Bentley Bulletin

25-092

Subject: USA RECALL CAMPAIGN – Bentley Continental GT, Continental GTC and Flying Spur V8 – RD69 Loose Screws On High-Pressure Fuel Pumps (RE25/41)

Figure 1 – High pressure fuel pump location

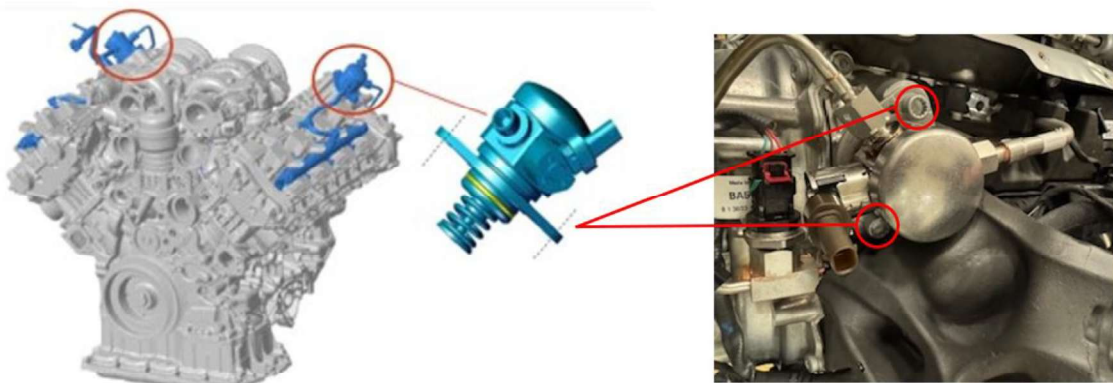
A torque check is required on the high-pressure fuel pump fixings for both Bank 1 and Bank 2. The fixings must meet a minimum torque value. If the torque is below this value further action is required.

- If the measured torque is greater than or equal to (\geq) 18 Nm, and the pen mark position remains unchanged, the fixing connection is OK.
- If the pen mark has moved position, this means the torque of 18Nm has not been achieved and the fixing connection is Not OK.

If a fixing connection is Not OK, replacement of the pump and fuel lines on the associated bank, and fixing screws is required. Full procedural steps are detailed in the Work section.

Figure 1 – High pressure fuel pump location

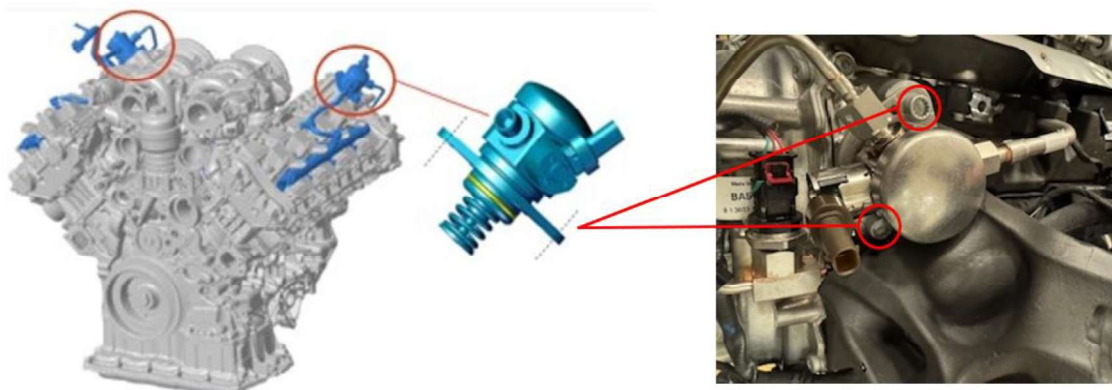
A torque check is required on the high-pressure fuel pump fixings for both Bank 1 and Bank 2. The fixings must meet a minimum torque value. If the torque is below this value further action is required.

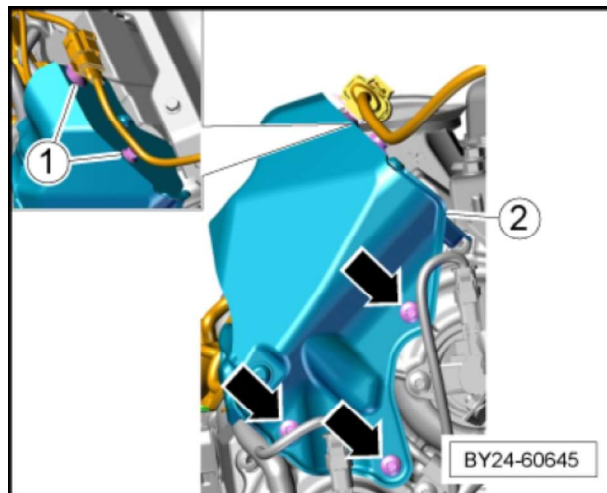
Remove and DISCARD the "starlock" washers -circled- and remove the Heat shield from the engine bay.

Use a long pick to remove the lower washer. A magnet may assist with retrieval.

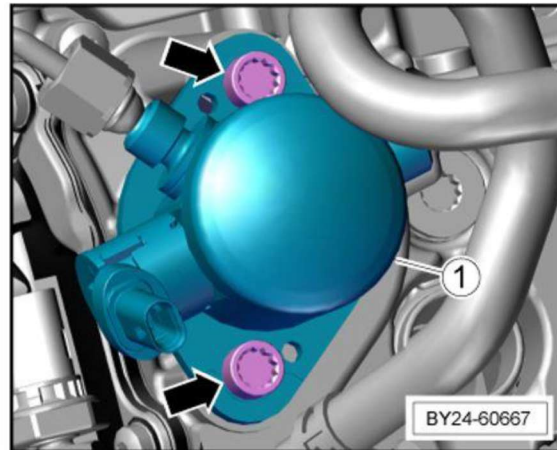
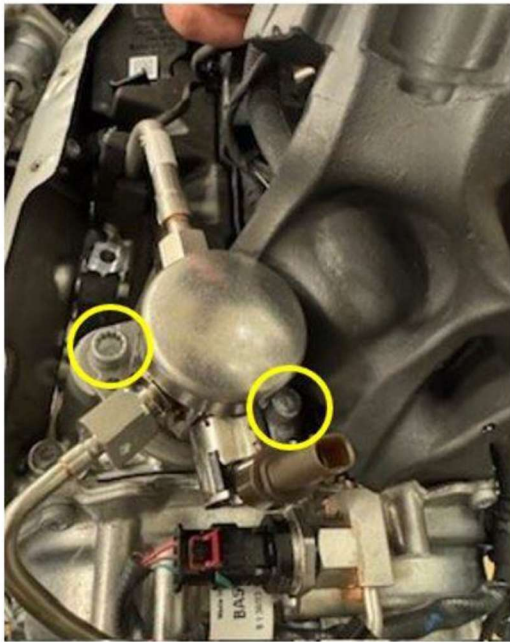
Unclip wiring <1> from the crash protection covers.

Remove the 3x fixings -arrowed- (8) Nm, then withdraw the crash protection assembly <2> from the engine assembly

Carefully Peel back the sound proofing material to expose the high pressure fuel pump and associated fixings.

Ensure that care is taken when manoeuvring the soundproofing material, do NOT tear the material, as a replacement will be required.

You will now have access to the required fixings <circled> to perform the below steps. Please refer to the next section for instructions.
